# TECHNICAL BULLETIN

**MODEL/DERIVATIVE:**  
220/420, 620 Turbo, 820

**Bull. No:** 0016  
**CDS. ref:** R6580bu  
**Issue:** 1  
**Date:** 21.02.96

**PROBLEM:**  
CYLINDER HEAD GASKET - CHANGE TO TYPE FITTED

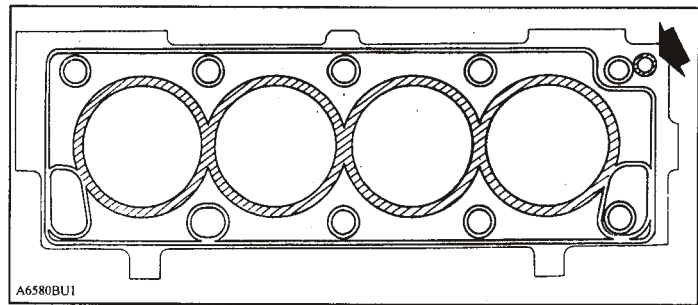
- Inspect mating face for dents or significant scratches (i.e. scratches that may be felt with finger nail) which traverse the shaded areas shown in the illustration (areas include cylinder fire rings and oil gallery). A critical area requiring close inspection is the 4mm wide area which circles the high pressure oil feed in the head (arrowed on illustration).

If any point within the shaded areas cause concern as to its condition, it is likely that the new steel gasket will not seal effectively. If this is so, the pre change point gasket should be fitted (see parts fiche).

If fire face condition is satisfactory, the new steel gasket may be fitted after first removing the cylinder block restrictor (if fitted) located in the cylinder block high pressure oil feed.

**Note:** If for reasons detailed above the decision is to fit the pre change point gasket to a post change point engine then a cylinder block restrictor must be fitted, part number UAM5038, fit into the oil gallery counterbore flush with top of block face.
